HYDROLOGY L22/D19 FOUR PLANS

RE: Mountain Shadows Estates

I find that notwithstanding the repeated verbal indications furnished to representatives of your office, I still don't have adequate information to accept your drainage plan. My objections are as follows:

Drainage Report

FIGURE 2

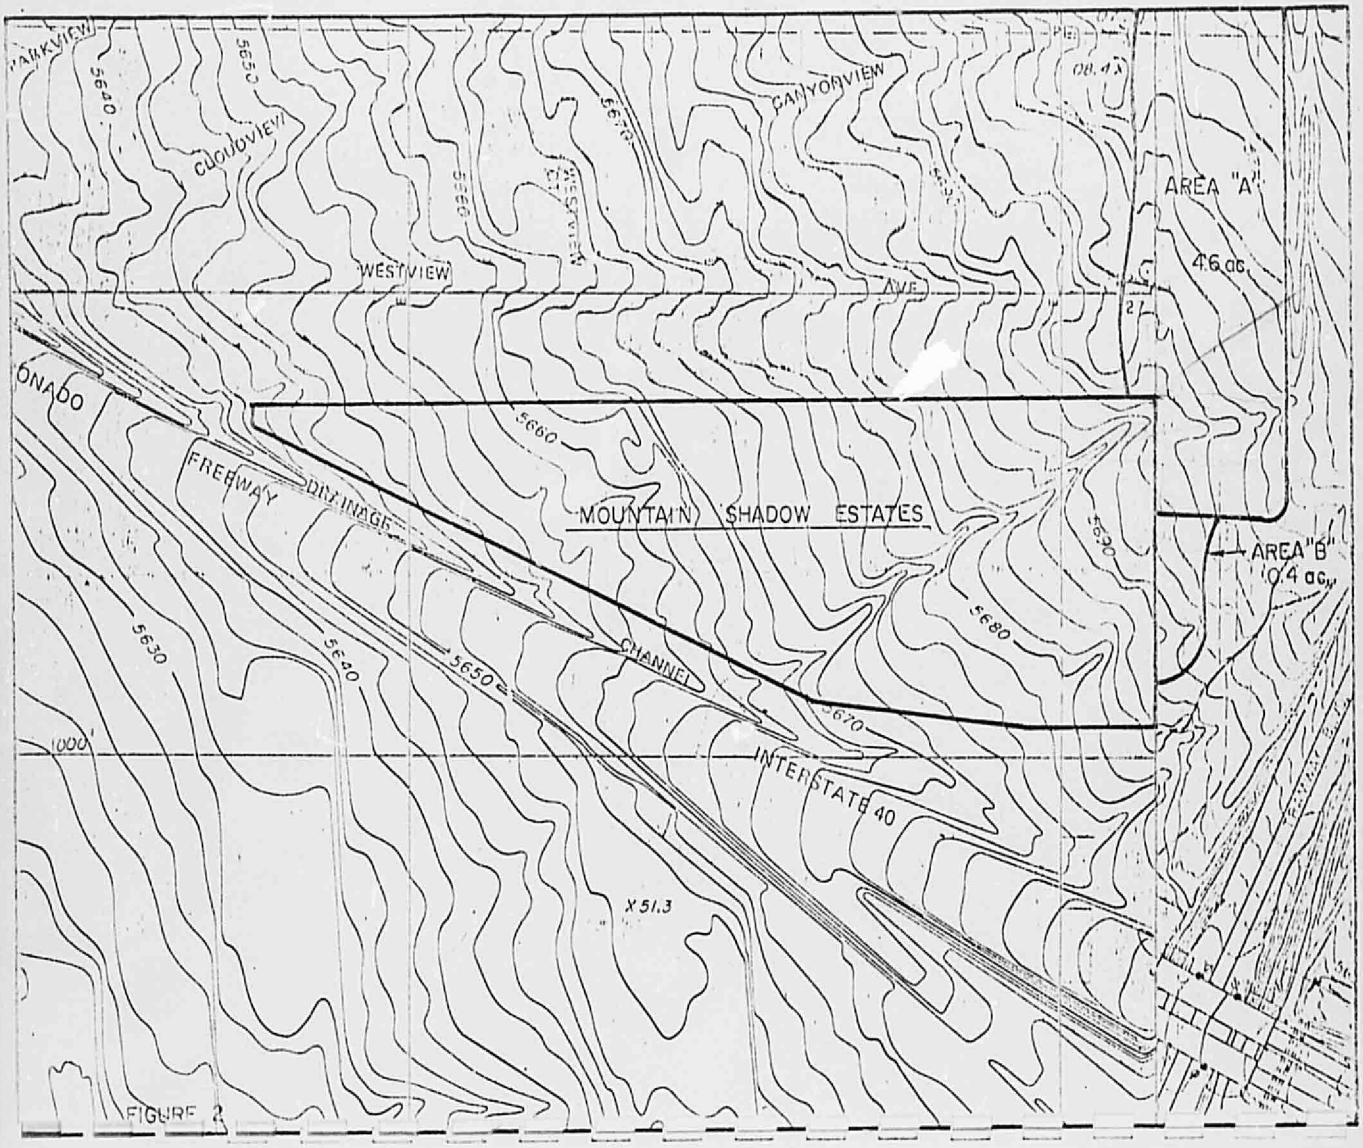
1. No provisions are made for the collection or conveyance of the water originating from the east across this property; The offsite Area B, drains to this parcel and cannot be routed to the south, without the concurrence of the owner, nor can the southernmost one-fourth of Area A.
